# Product Change Notification (PCN)

PCN Number	507601	Date Issued	September 04, 2019
Reason for Change	Change to Product		
Change Type Description	This letter is to inform you that changes are being made to the part(s) identified in this Notice. The change may affect the fit, form, function or appearance of the parts, or it may result in a change to the specification. The pictures below show an example of the possible differences.		
Assessment of Change	Passed FAI		
Internal Molex Qualification Date	August 05, 2019		
Sample Availability Date (Changed Part)	August 05, 2019		
Planned Implementation Date	March 04, 2020		
Method of Identifying Change	Product made after planned implementation date can contain the change

- PCN#507601 - 10B & 24B HC Top & Side Entry Hoods Round shaped

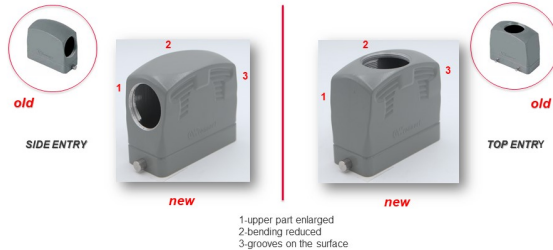
- As part of our continuous improvement process, we/Molex HDC have upgraded our 10B & 24B High Construction hoods, Top & Side entry – same as already done with the 16B size.
- The upper part of the hood has been enlarged (see picture point 1), the bending at the top has been slightly reduced (see picture point 2).
- This change will ensure a better performance even when connected to cable glands of bigger sizes, such as PG29 and M40.
- Even the aesthetic of the surface has been renewed with a new design for the grooves (see picture point 3).
- This change involves both the form and the function of the products.
- See attached impacted parts list.
- Qualification Reports and samples available upon request after the date shown above.
